Subject: Natural Recovery Monitoring Plan for Surface Water and Sediment Not Approved
HARP Site Long Term Monitoring, BRRTS # 02-08-587669

The Natural Recovery Monitoring Plan for Surface Water and Sediment dated April 15, 2021 submitted to the Department of Natural Resources (DNR), as required by the November 2018 Negotiated Agreement for the Hayton Area Remediation Project (HARP) Site Long Term Monitoring, is not approved.

Attachment: DNR Comments on the Natural Recovery Monitoring Plan for Surface Water and Sediment
HARP Site Long Term Monitoring, BRRTS # 02-08-587669

**HARP POST-REMEDATION
 NATURAL RECOVERY MONITORING PLAN**

FIGURE 2

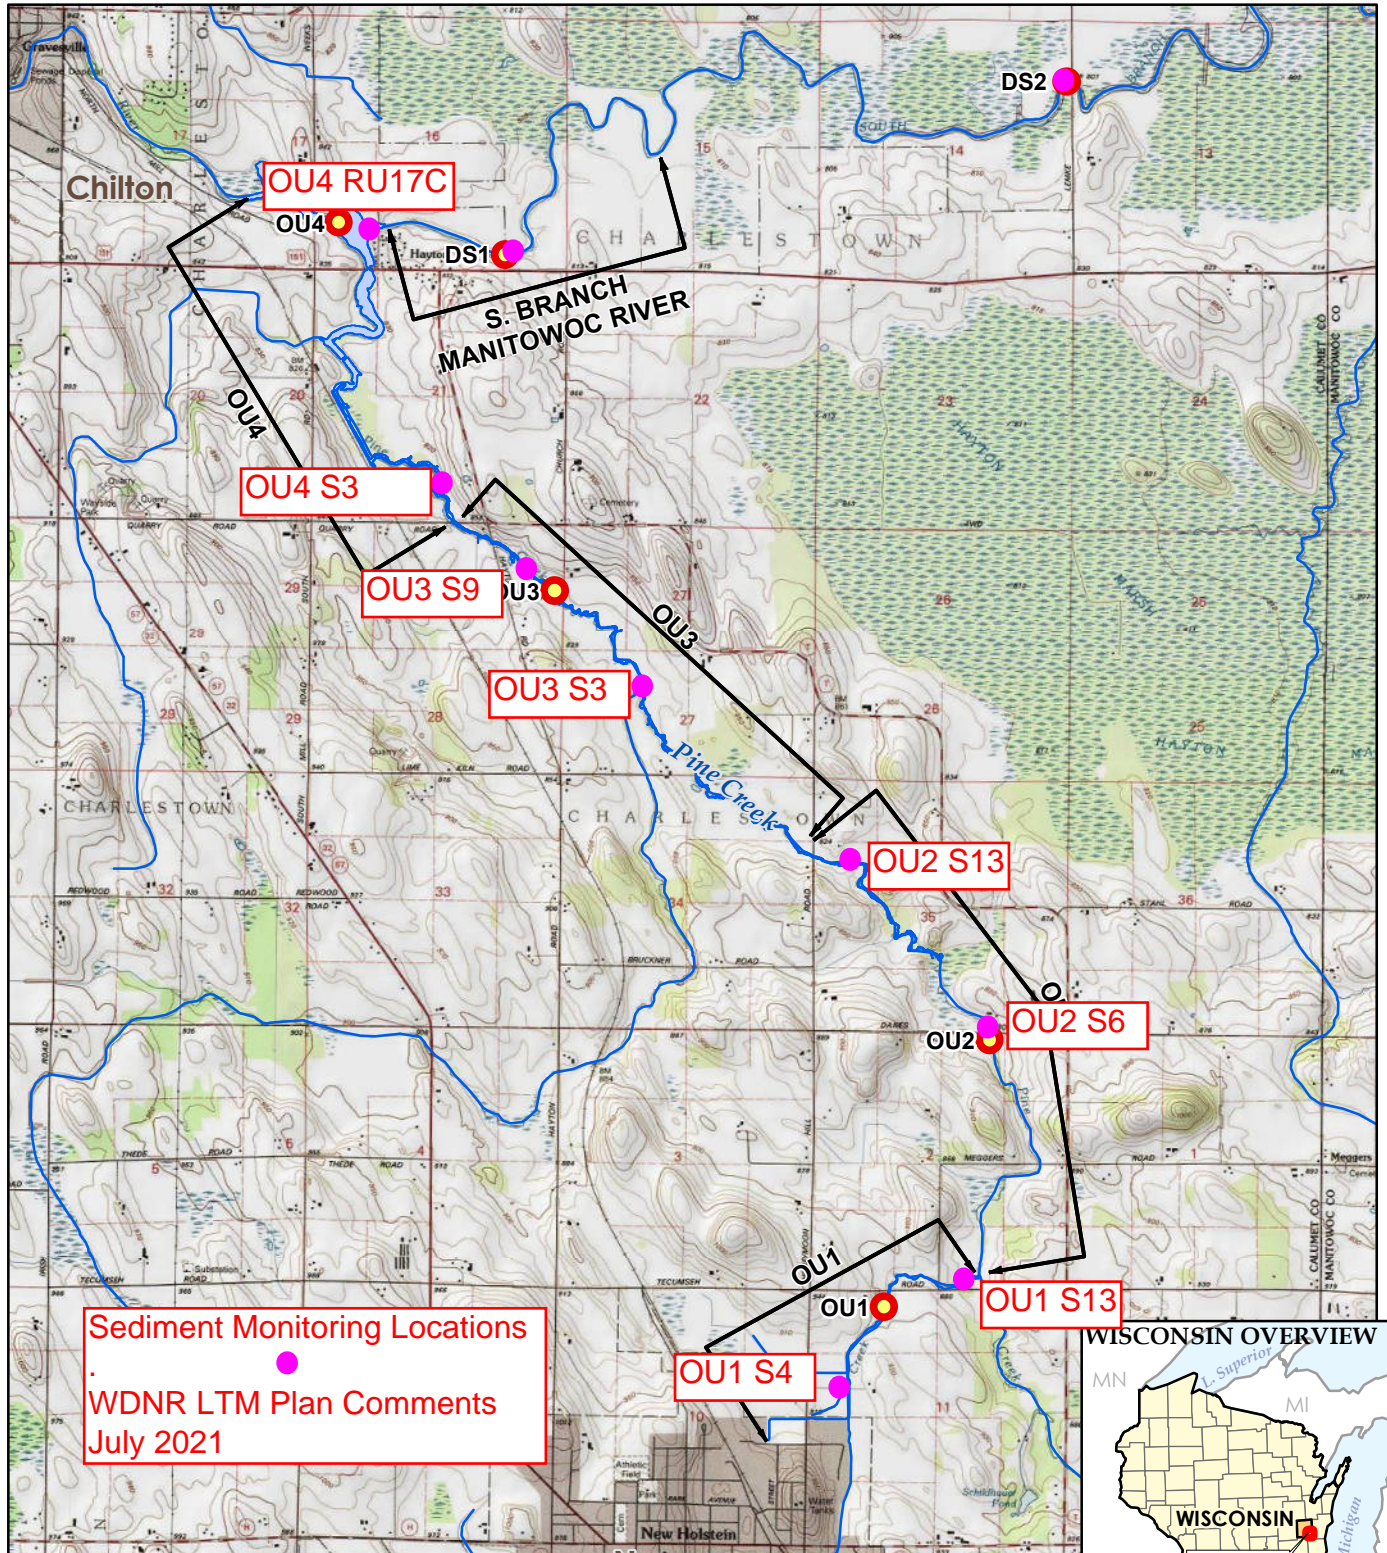
7. Section 4.1 Scope of Work, In Channel Sediment Sampling – The sampling locations should be selected based on the existing post remedial action sampling. The following locations (see attached map) have shown elevated sediment PCBs and should be monitored for sediment PCBs in this plan:

- a. OU1: S4, S13
 - b. OU2: S6, S13
 - c. OU3: S3, S09
 - d. OU4: S3, RU 17C (vicinity)
 - e. OU5: Past location of the 11 ppm PCB result, the proposed DS2 at Lemke Rd.

Additional sampling locations in each OU should be selected based on field verified geomorphology i.e. poling survey. Representative areas of deposition e.g sediment trap, point bars, and quiescent areas, and impacted areas that were not remediated should be included in the in-channel sampling locations as part

of the natural recovery monitoring. These sampling locations may be adjusted periodically with concurrence from DNR based on depositional rates determined with the poling surveys.
